ADDENDUM NUMBER ONE (1)

Project: Replacement Facility for
Tippah County Hospital
Ripley, MS
PN: 18015

FROM: Dean and Dean/Associates Architects, P.A.
4400 Old Canton Road, Suite 200
Jackson, MS 39211
(601) 939-7717

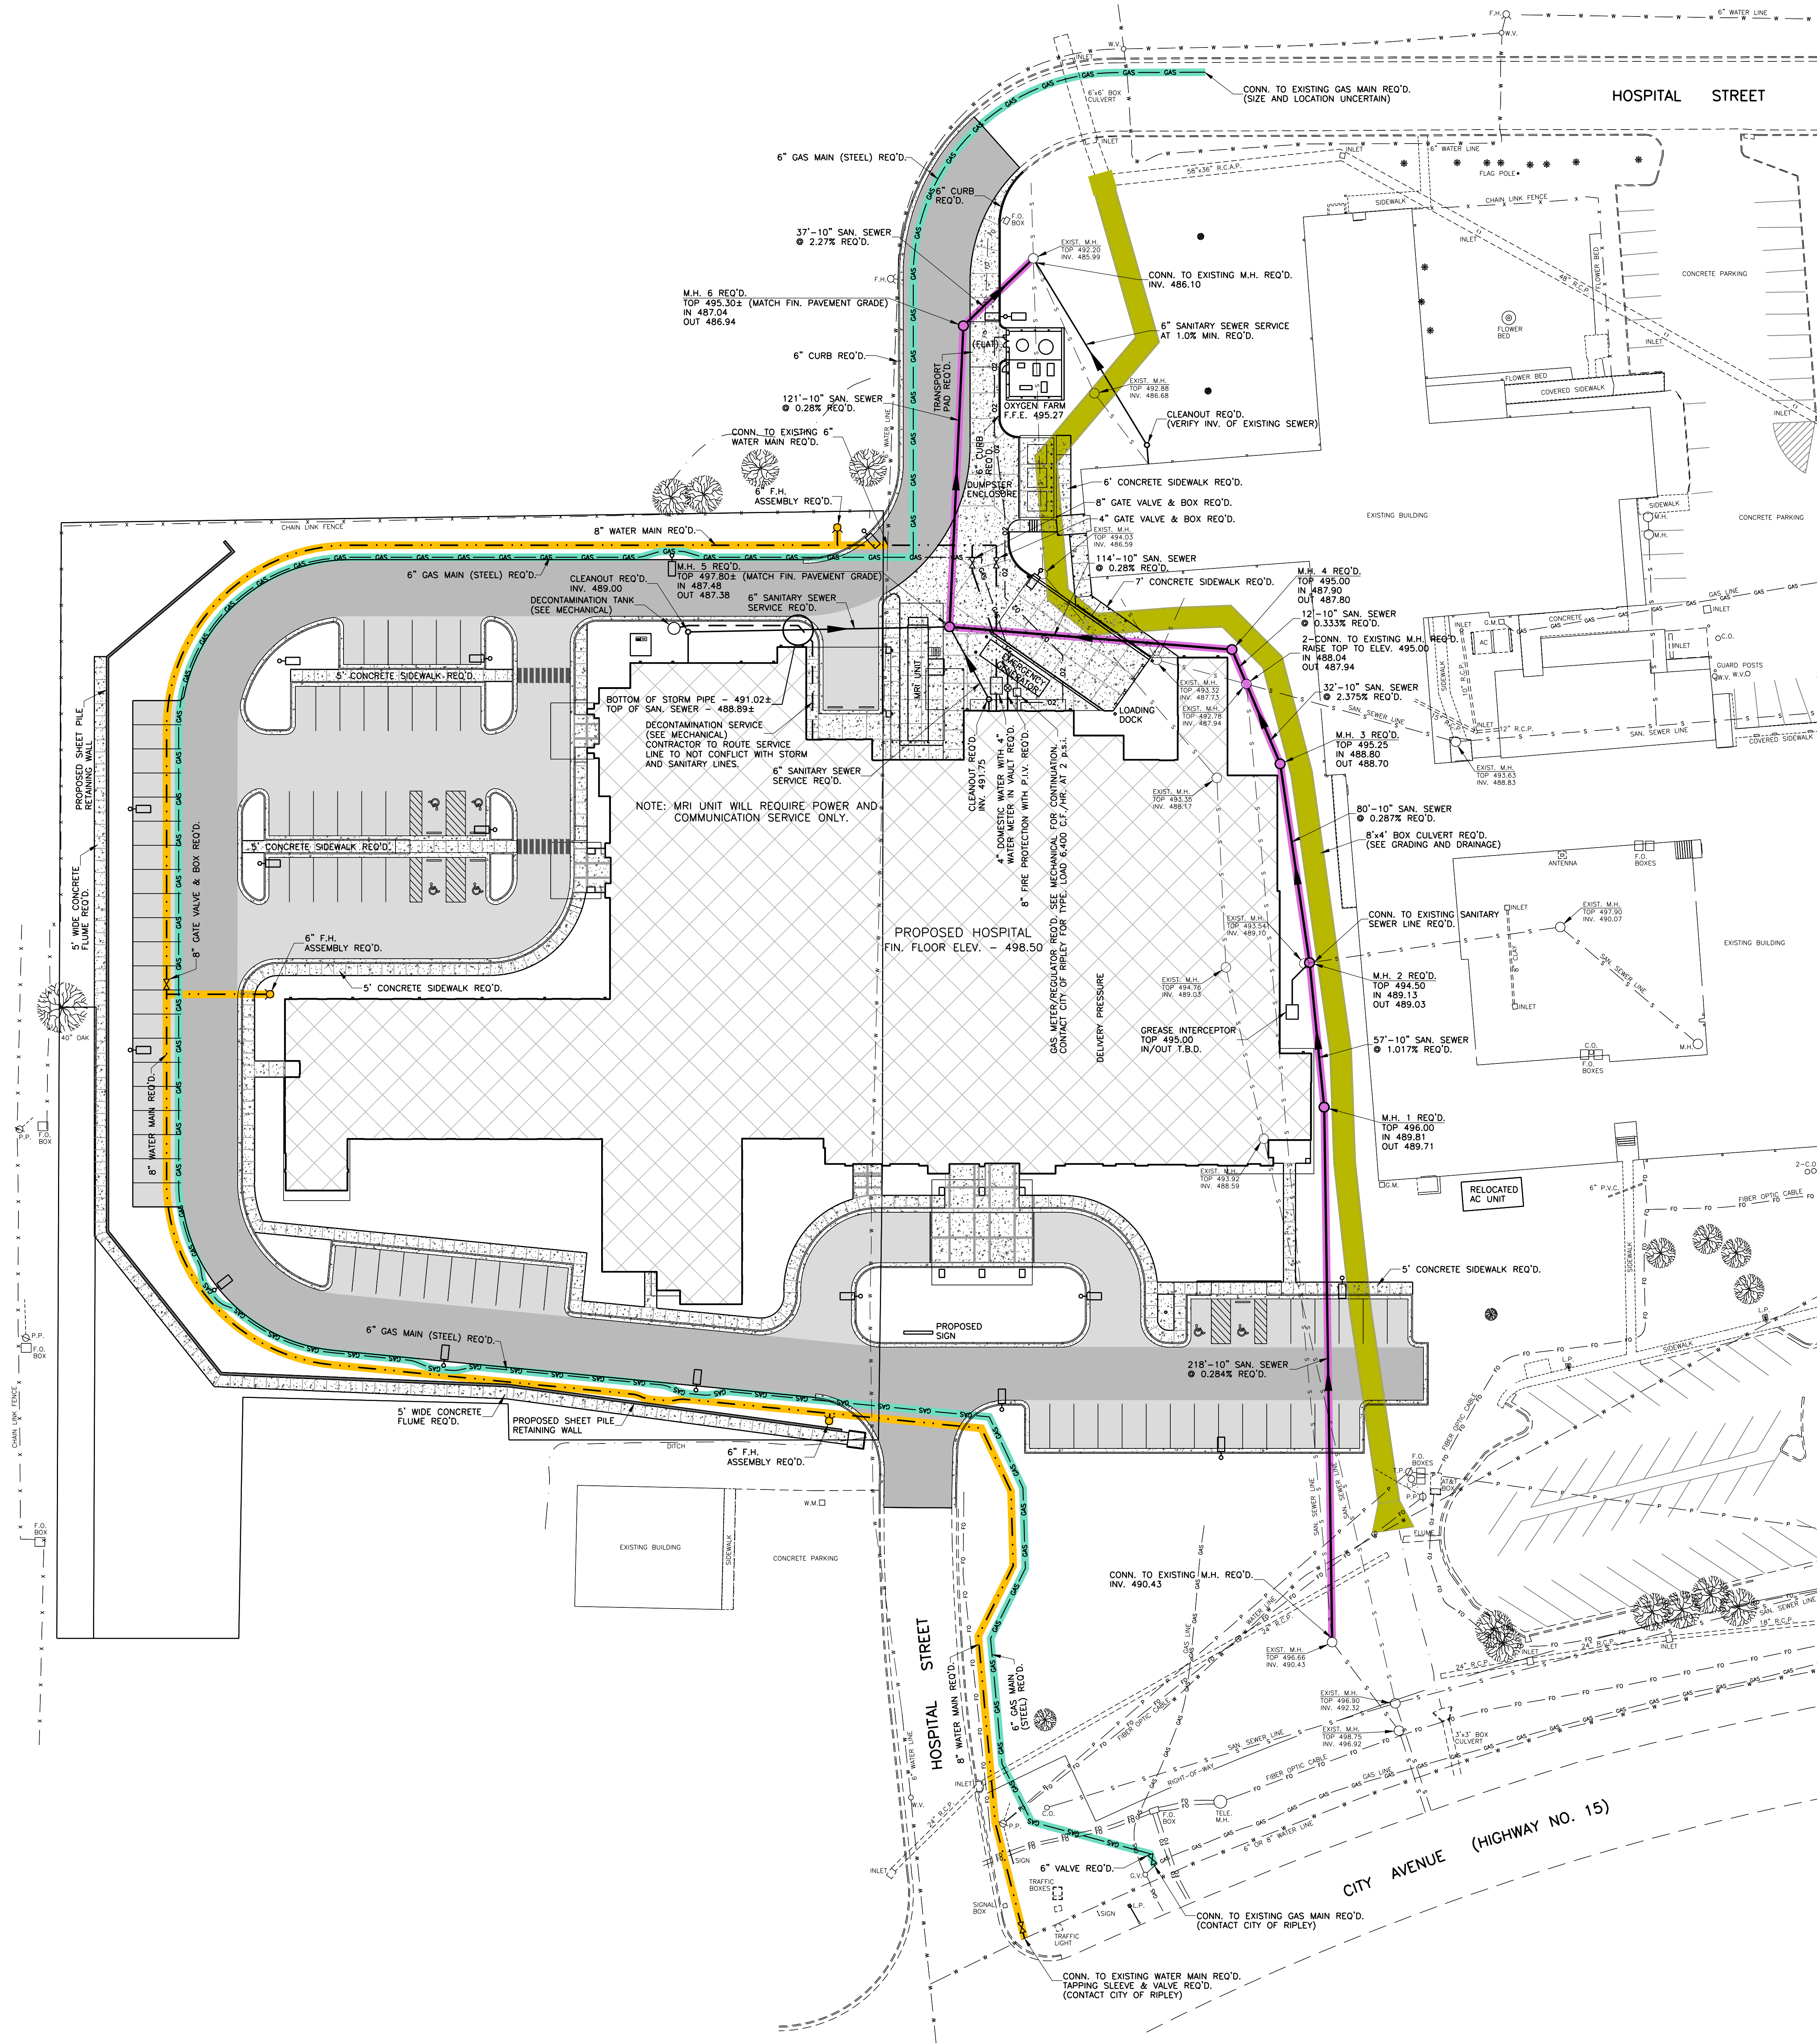
- 1.2 Enclosed is revised C2.2-'Grading and Drainage' with pipe size changes. Also, the 8'x4' concrete box culvert wall thickness should be modified for low cover per Standard Sheet 288 in the drawings.
- 1.3 Enclosed is revised C3.1-'Utility Plan' including a color legend for the utilities included in Alternate No. 1.

ENLARGED MEDICAL GAS PLAN - PART "3"

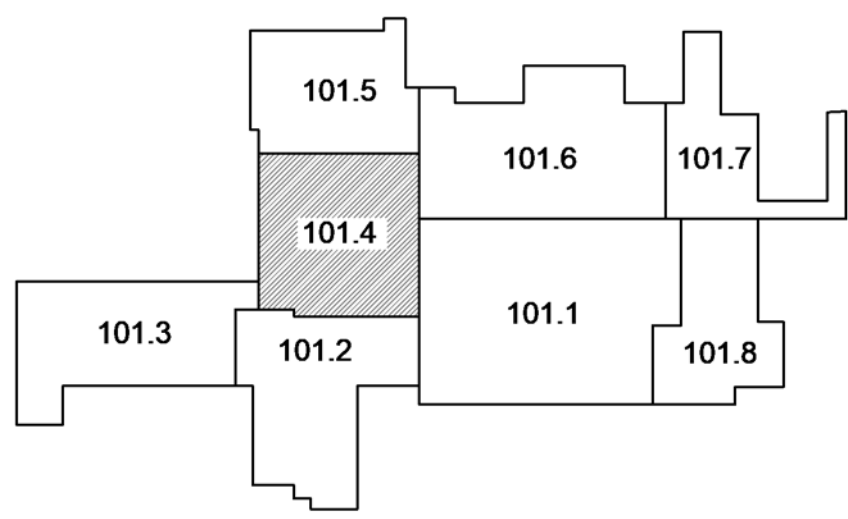
1. Sheet FP101 - 1/FP101 Enlarged Fire Sprinkler Plan. Change size of site fire piping entering the building from 6" to 8" to match Civil Drawings.
2. Sheet P201.3 - Enlarged Medical Gas Plan Part "3". Delete sheet in its entirety and replace with the revised sheet attached. Changed piping system designations to be consistent with the medical gas outlets.

1 PARTIAL FLOOR PLAN - LIGHTING PART D
SCALE: 1/8" = 1'-0"

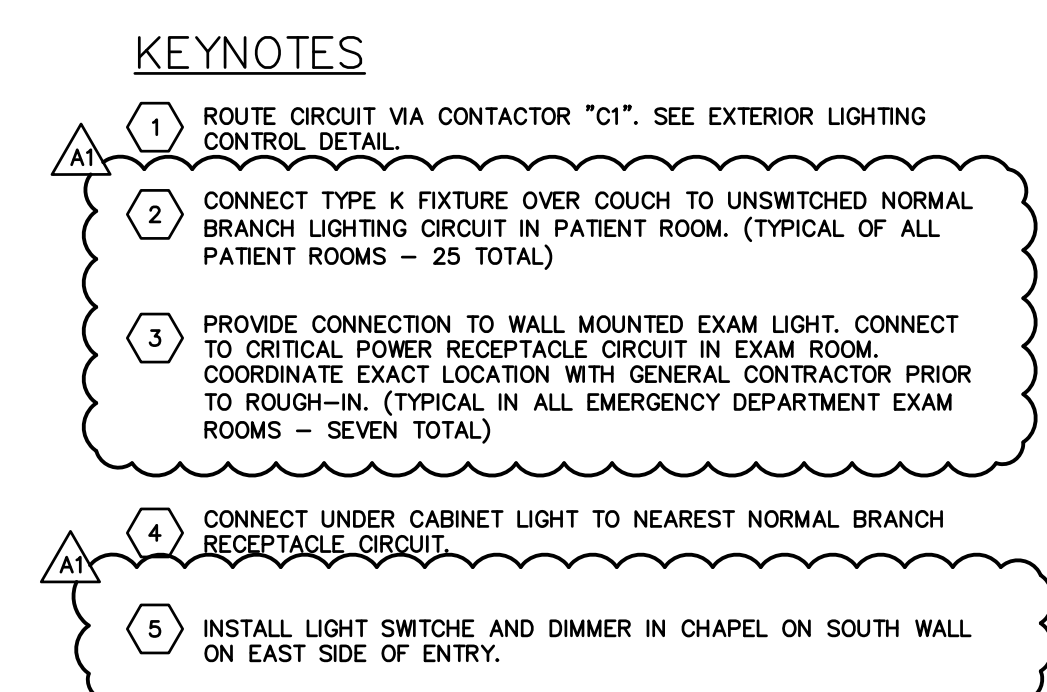
1. Fixture type "K" has changed to fixture type "H" in the following rooms:
 - a. X-ray 504
 - b. Control Station 503
 - c. CT 501
 - d. Ultra 517
 - e. Bone Density 515.
2. Type "A2" light fixtures in rooms Ultra 517, and Bone Density 515 have been omitted.
3. The downlight layout and quantities have been modified in Ultra 517.
4. The switching has been modified in Ultra 517.
5. Fixture Type "V" has been added to the light fixture in Decontam Shower 1146.

6. A circuit has been shown to connect a type "Q" fixture to the other type "Q" fixtures in Teck 513.
7. Dimmers have been added to the lighting in OR 621.
8. Dimmer have been added to the lighting in Minor Procedure 623.

1 PARTIAL FLOOR PLAN - POWER PART B
E301B SCALE: 1/8"=1'-0"

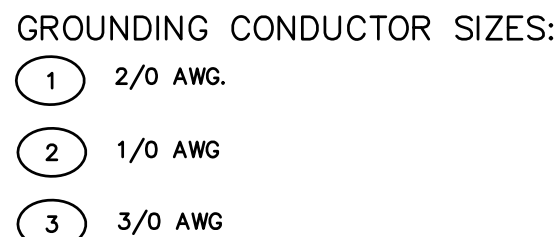
1. A keynote has been added to clarify connections to motorized shades in Inpatient Rehab 950.

12 PATIENT ROOM LIGHTING CONTROL DETAIL
E602 SCALE: NOT TO SCALE

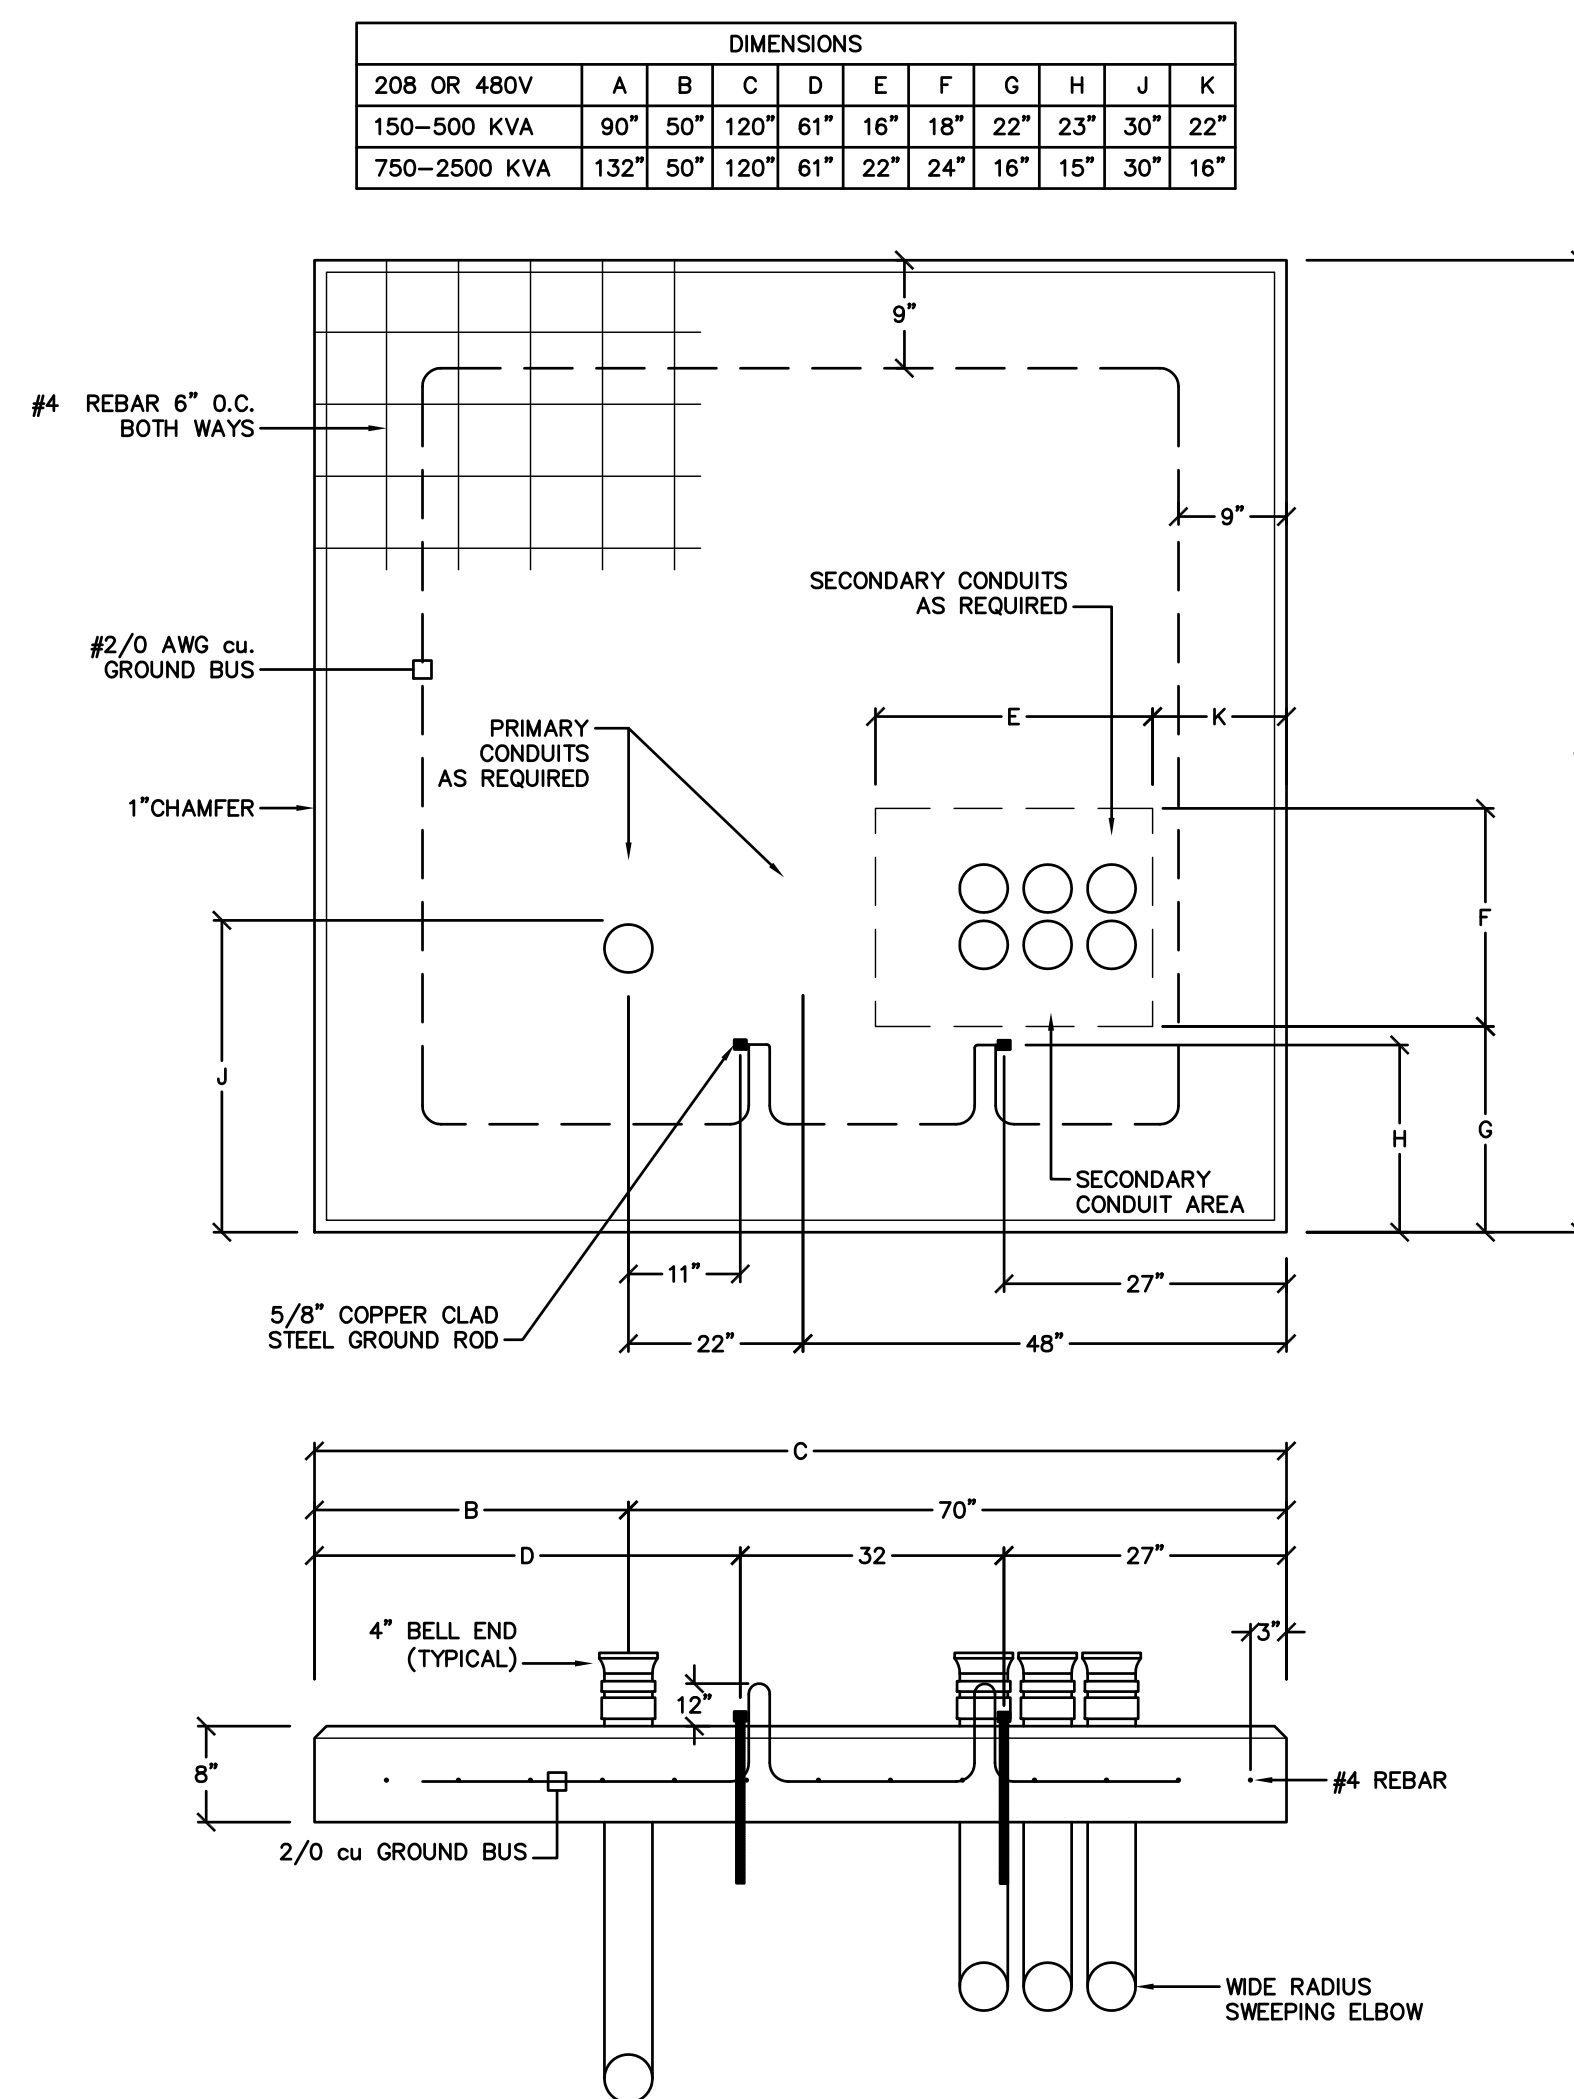
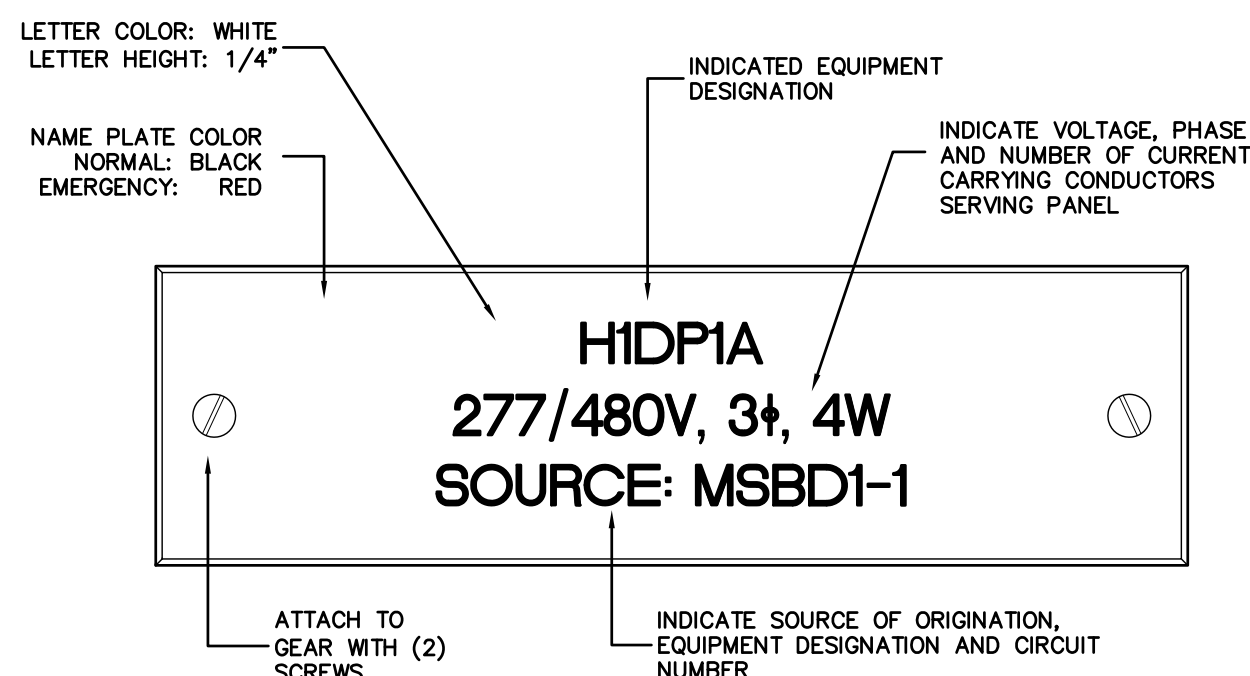
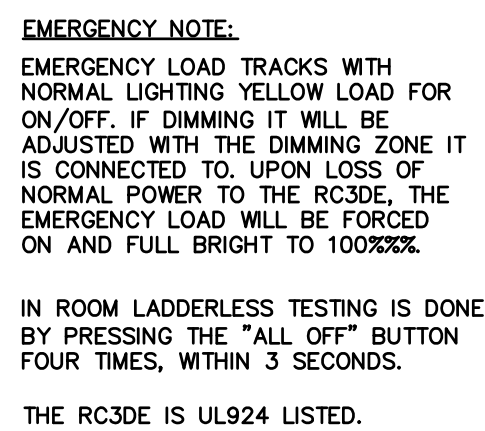
1. Lighting Control Details have been added to this sheet.
2. A Patient Room Lighting Control Detail has been added to this sheet.
